Indiana University East

EA000B – Multi-Building – EA801 RM 326,
EA803 RM076 Classroom Update
IU# 20250563

ADDENDUM NO. 1
14218

31 March 2026

THIRD FLOOR DEMOLITION PLAN
A131

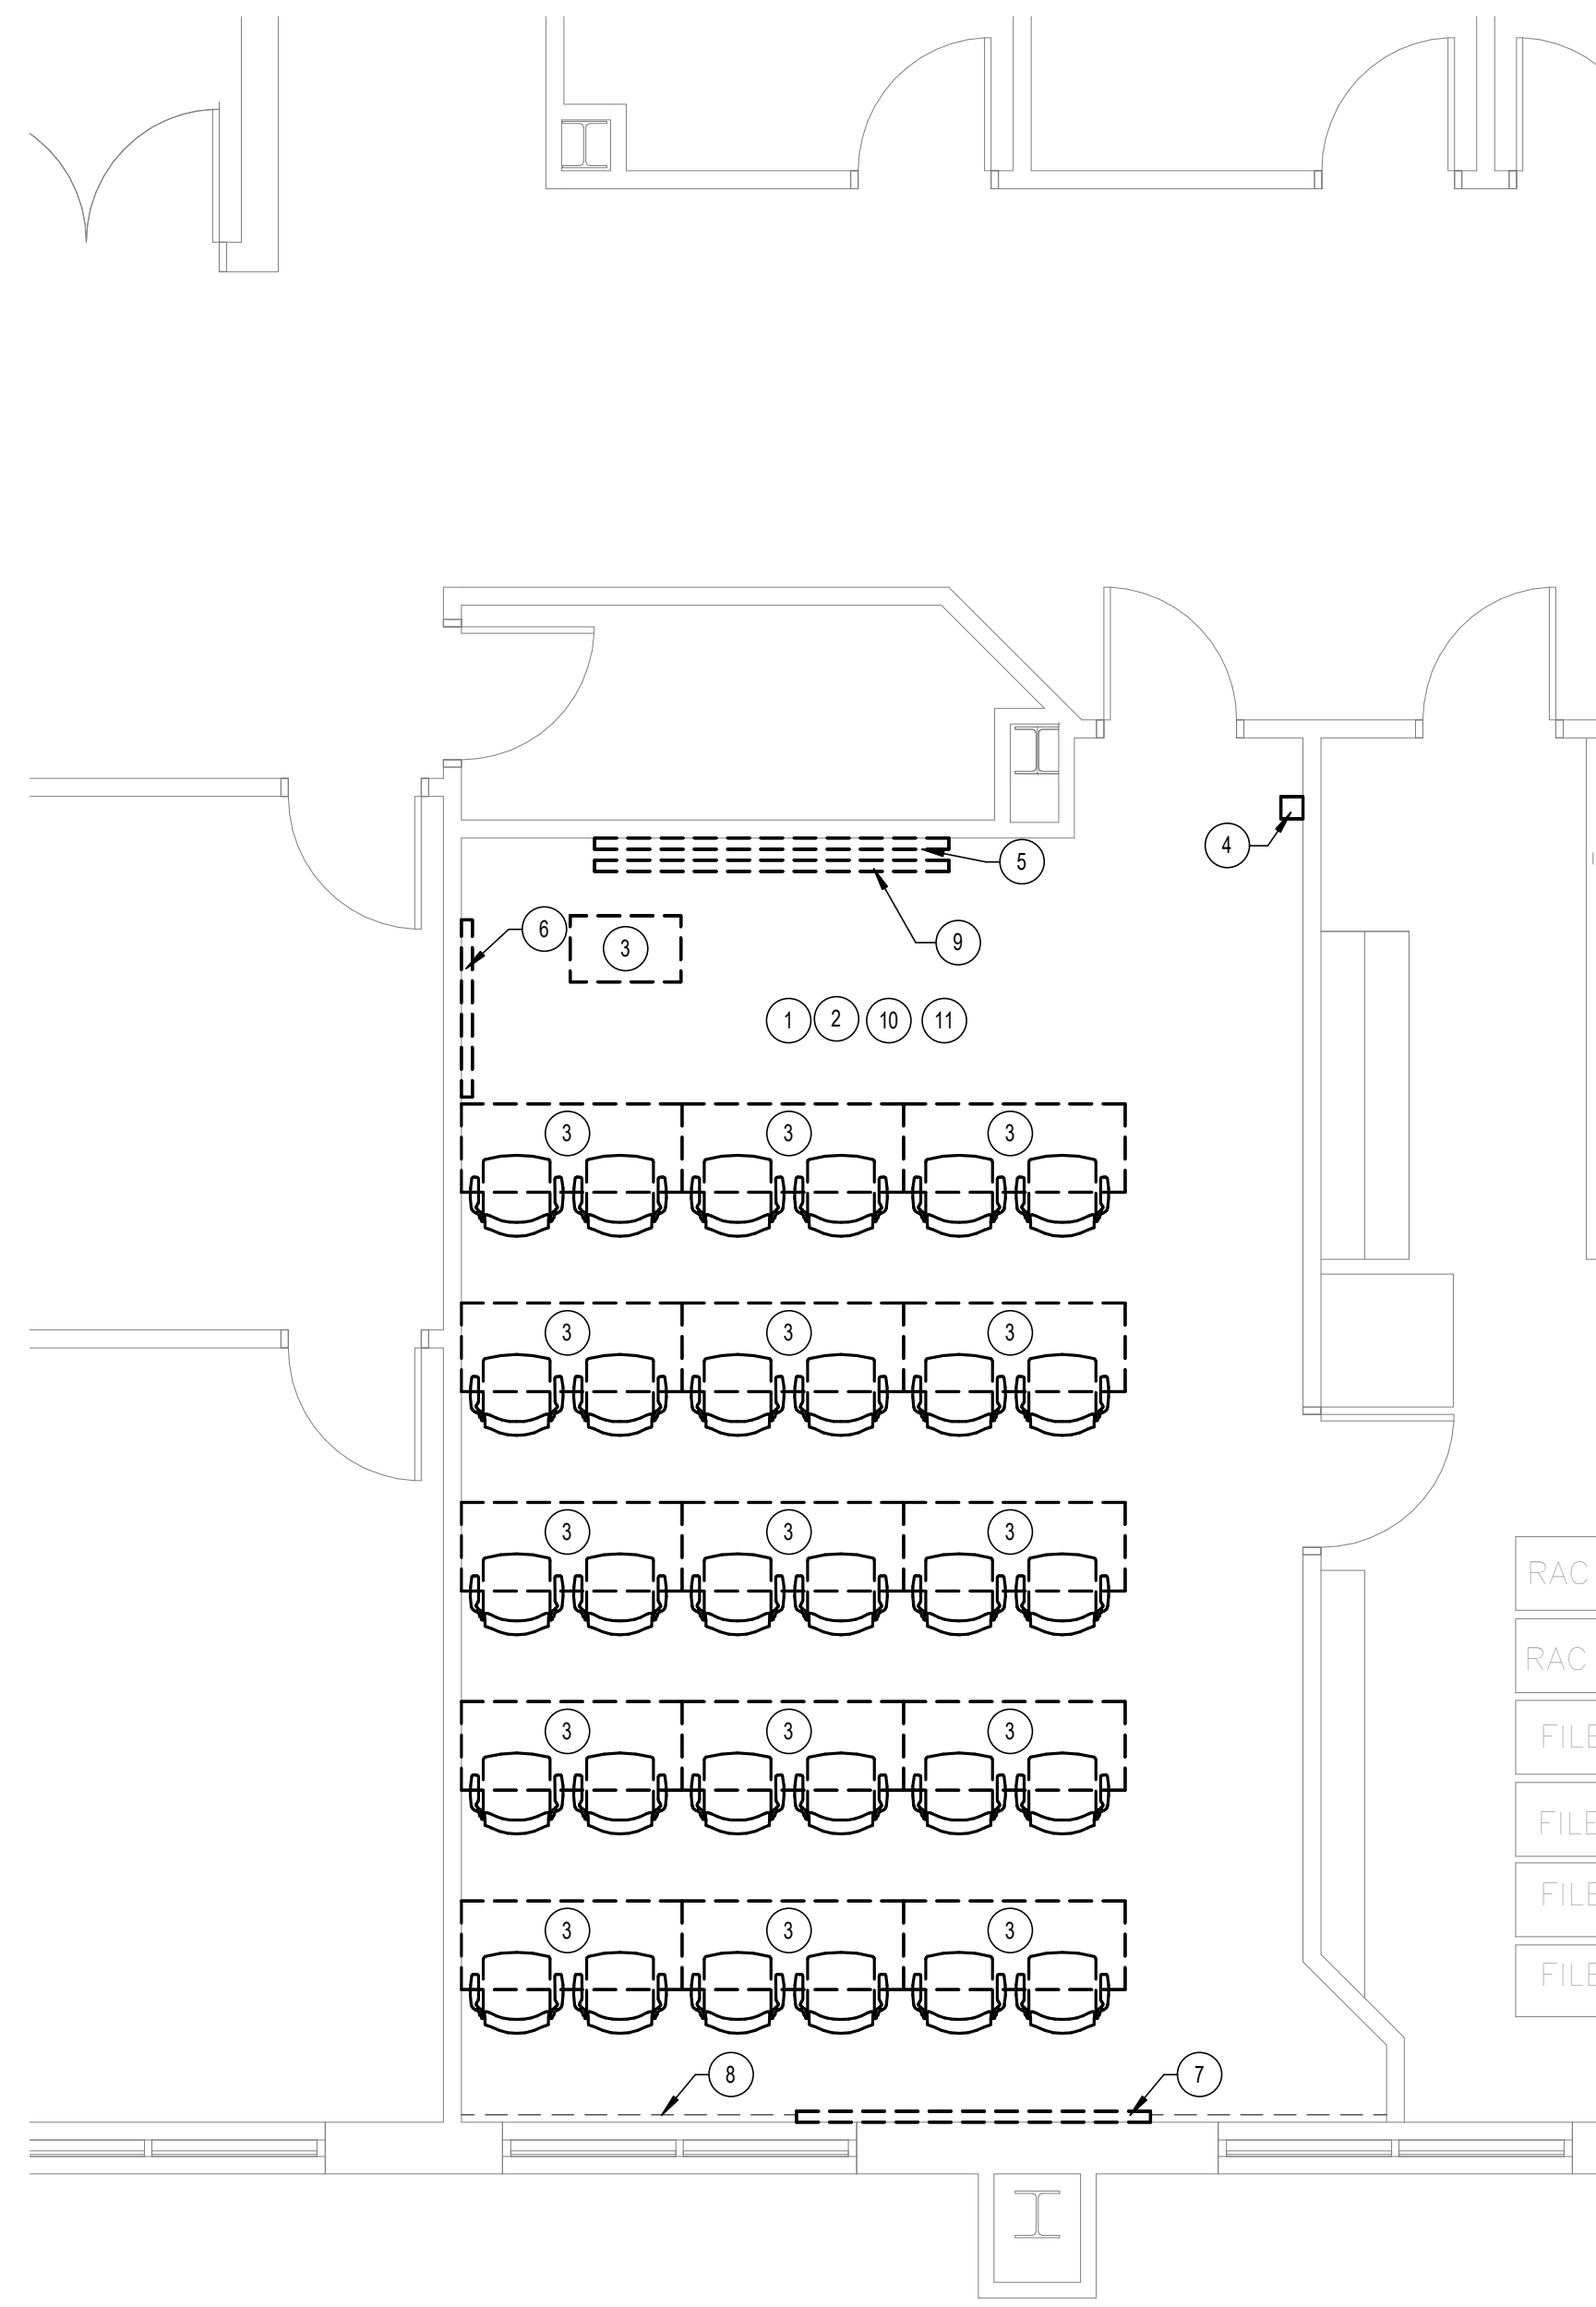
- Q. Raper Hall. A131 Note 9 is missing from the key notes. Is note 9 the projector screen?
 - A. Note 9 refers to the projector screen and brackets. Refer to attached revised sheet.

1. EA801 Tom Raper Hall Sheet A131 - Third Floor Demolition Plan
 - a. Add Specific Demolition Plan Note 9 to read as follows:
"9. CONTRACTOR TO REMOVE AND REINSTALL PROJECTOR SCREEN BRACKETS. COORDINATE WITH OWNER ON REMOVAL AND REINSTALLATION OF PROJECTOR SCREEN."

- CONTRACTOR TO REMOVE AND REINSTALL PROJECTOR SCREEN BRACKETS. COORDINATE WITH OWNER ON REMOVAL AND REINSTALLATION OF PROJECTOR SCREEN.
- REMOVE EXISTING SPEAKERS AND MICROPHONES FROM CEILING. PATCH / REPAIR / PREPARE ADJACENT SURFACES AS REQUIRED FOR NEW CONSTRUCTION.
